MOD2022/0363

Project **BILGOLA**

Address **1A THE SERPENTINE, BILGOLA BEACH**

S4.55 AMENDMENT: REV C

Project **BILGOLA**
 Address **1A THE SERPENTINE, BILGOLA BEACH**
 Dwg Title **PLAN - MAIN LEVEL**

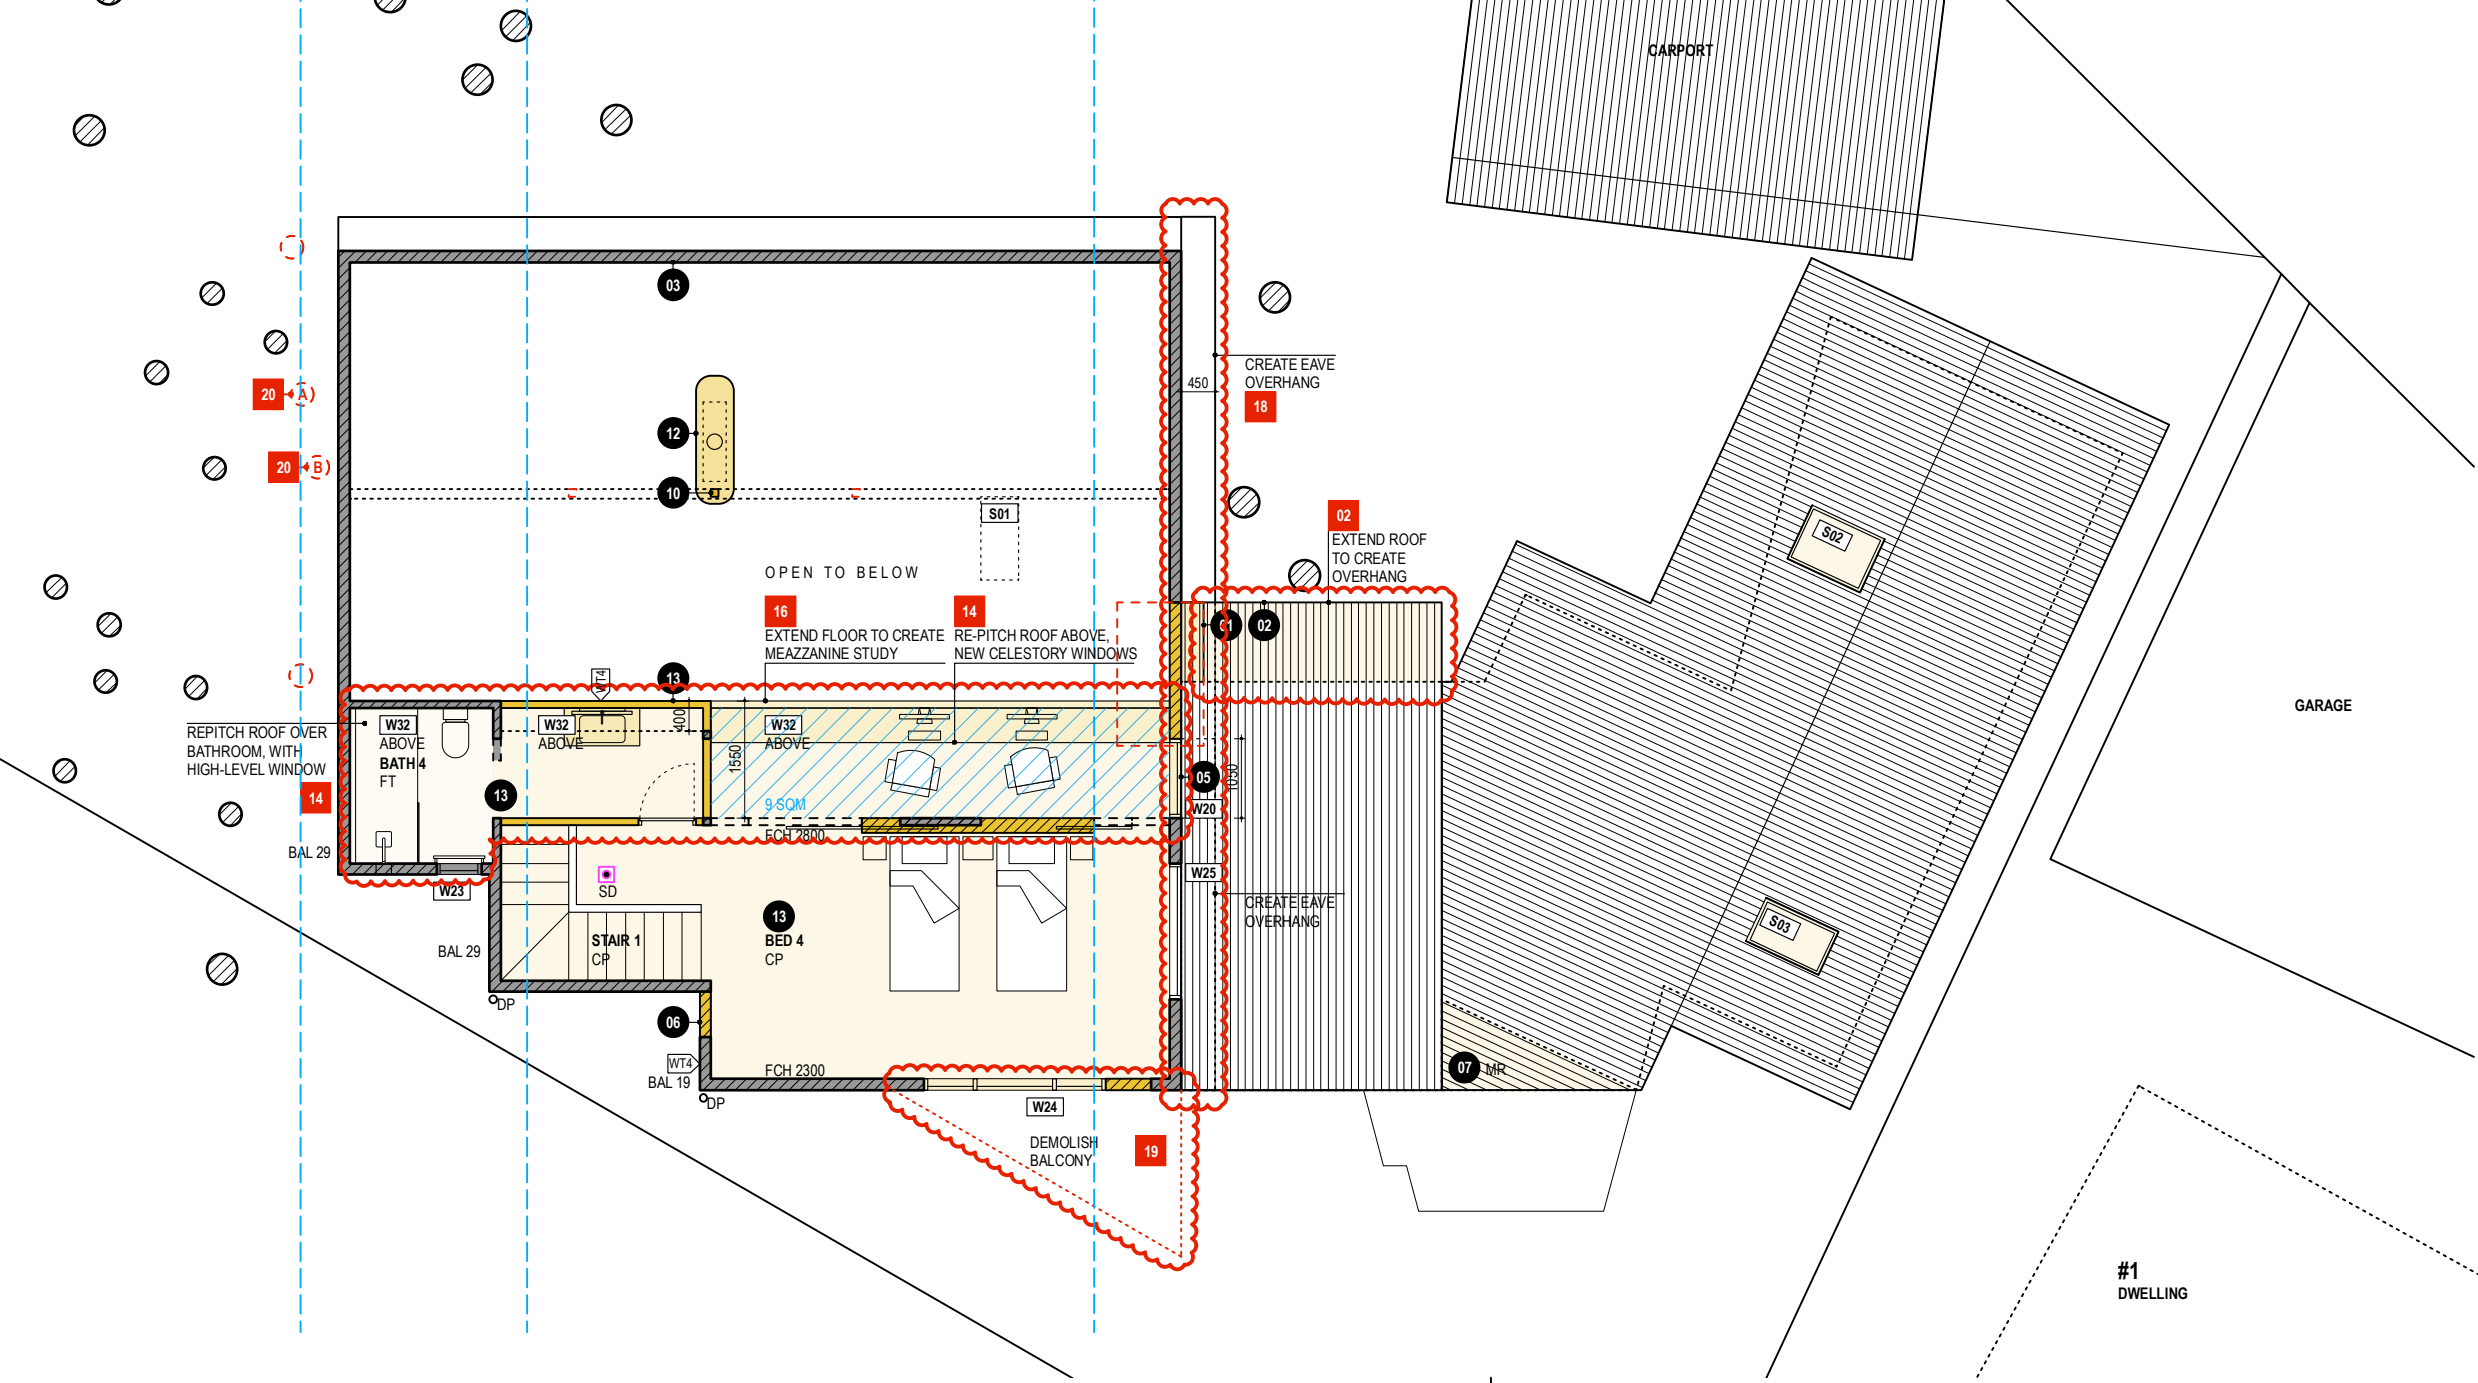
REMOVE SOIL NEAR WINDOWS TO MIN 400MM BELOW FLOOR, FOR BUSHFIRE, IMPROVED DRAINAGE, AND SURFACE WATER DRAINAGE TO COMPLY WITH BCA 3.1.3.3

MIN 450MM OVERHANG (BASIX)

REMOVE SOIL NEAR WINDOWS TO MIN 400MM BELOW FLOOR, FOR BUSHFIRE, IMPROVED DRAINAGE, AND SURFACE WATER DRAINAGE TO COMPLY WITH BCA 3.1.3.3

NORTH ELEVATION

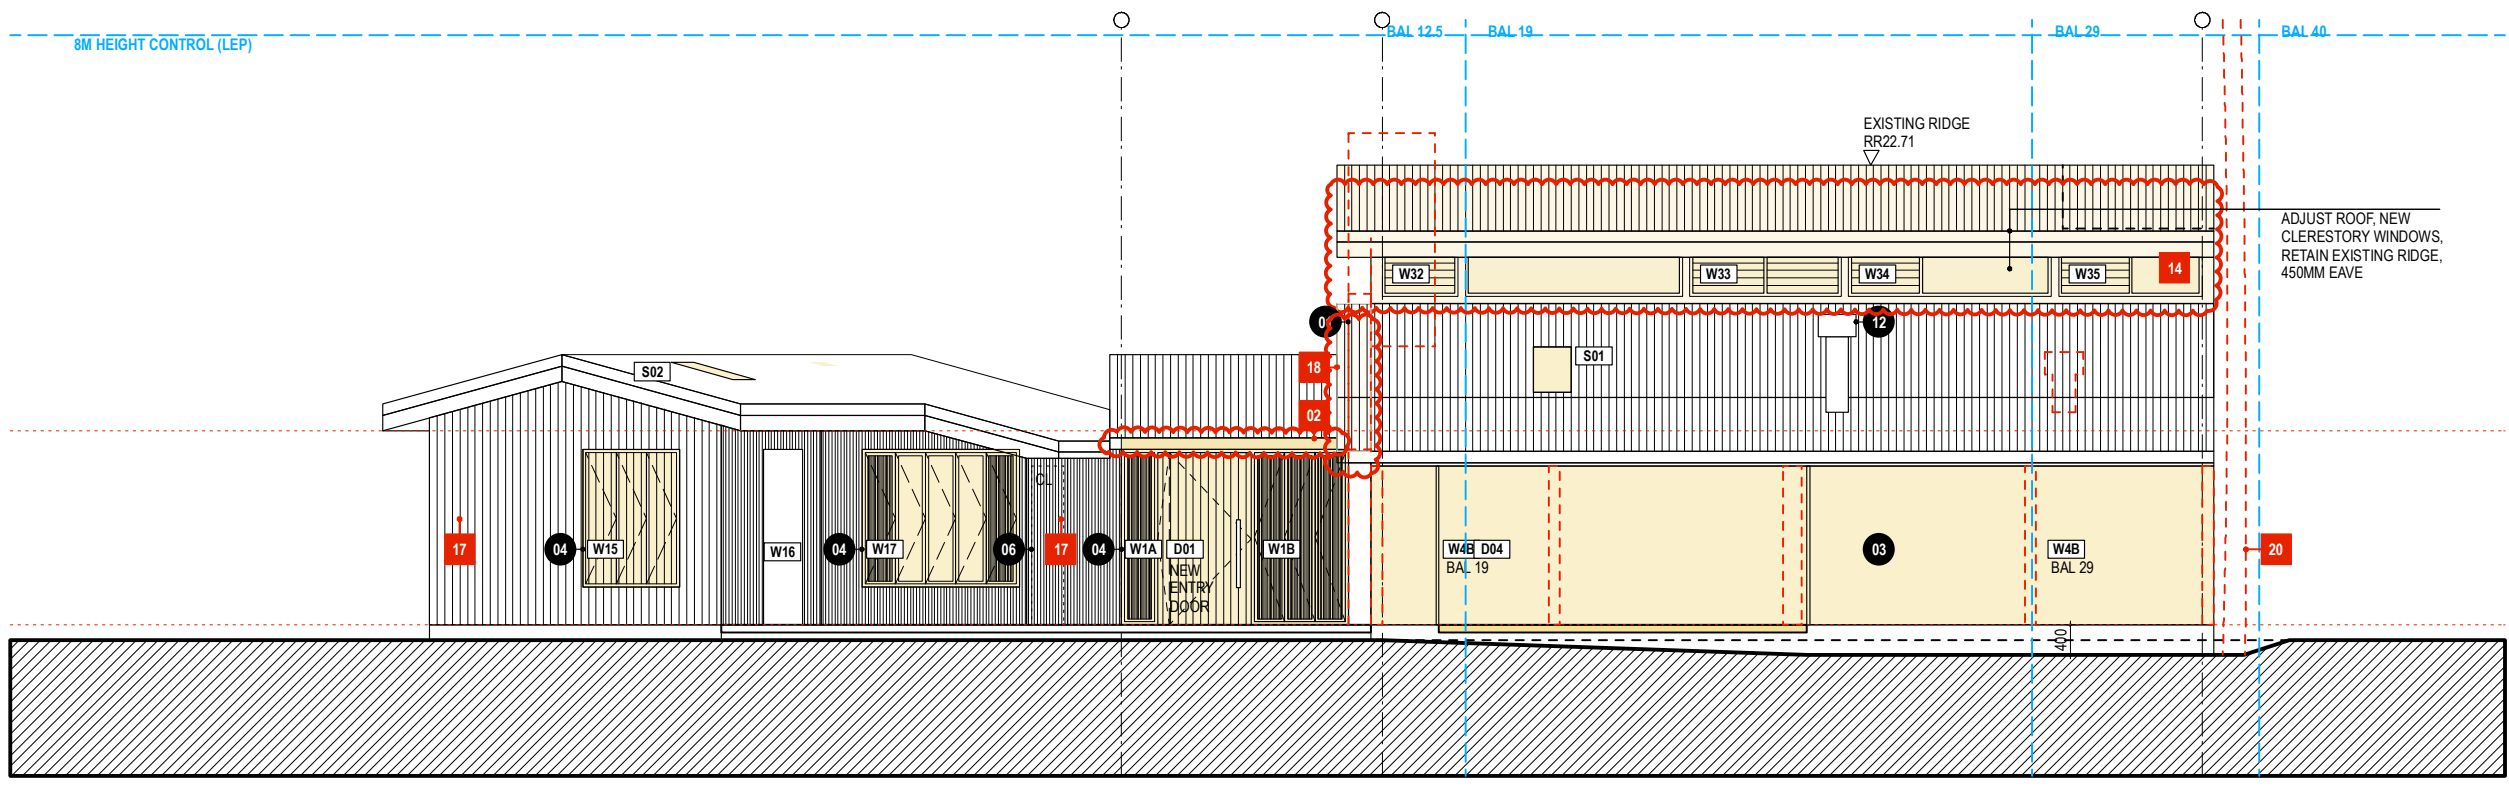
UNDERFLOOR AREAS OF BALCONY TO ALLOW CLEAR PASSAGE OF FLOODWATERS. (DA CONDITION 6)
